M25 junction 28 improvement scheme TR010029

9.85 Applicant's comments on Hinson Parry & Company on behalf of Mr and Mrs Jones of Grove Farm's response to ExA WQ2

Rule Number:	Rule 5(2)(q)
Planning Inspectorate Scheme	TR010029
Reference	
Application Document Reference	TR010029/APP/9.85
Author:	M25 junction 28 scheme, Project Team,
	Highways England

Figure 4.1 – Grove Farm's suggested location for noise attenuation fencing

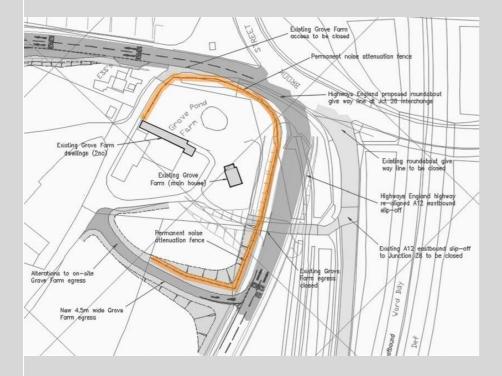
mitigation measures are included in the HE Scheme surrounding Grove Farm. Our **Drawing No. REDW-3396- 115**, previously issued, showed Grove Farm's suggested location of permanent noise attenuation barriers which would contribute towards the enhancement of Grove Farm's environment and mitigate increased environmental traffic noise brought about by the HE Scheme. HE proposals for additional landscaping or standard visual fencing will not provide any material benefit for traffic noise reduction [ExA question - PC2.3 (ii)]. HE has dismissed any need for noise attenuation barriers based upon their noise assessment and has not worked with Grove Farm with a view to include a noise attenuation barrier in the HE Scheme; only suggesting visual fencing [ExA question - PC2.4 (ii)].

4.2 Figure 4.1 shows an extract of our **Drawing No. REDW-3396-115** showing Grove Farm's suggested line for permanent noise attenuation fence (highlighted in orange):

As the impacts at Grove Farm are negligible there is no justification for Highways England to provide any permanent noise mitigation at this location given the substantial cost to the public purse that this would involve.

Further, the noise assessment shows that the current noise levels at Grove Farm are high, with higher noise levels only occurring at a limited number of other properties within the study area, principally on Colchester Road.

At Grove Farm the existing noise levels are dominated by noise from the M25 motorway mainline carriageway, which is elevated above the junction 28 roundabout, and above Grove Farm. The least beneficial noise impact of the Scheme at Grove Farm is on the first floor of the south-east façade, which also has the highest baseline noise levels. The contribution of noise at this receptor, from the different elements of the surrounding road network and the proposed loop road, is indicated in the following table.

The table shows that noise from the M25 carriageway is approximately 6dB higher than the total noise from the junction (all slip roads, the roundabout and the proposed loop). This in turn illustrates that reductions in noise from any road other than the M25 carriageway would have very limited benefits on the total noise levels at Grove Farm.
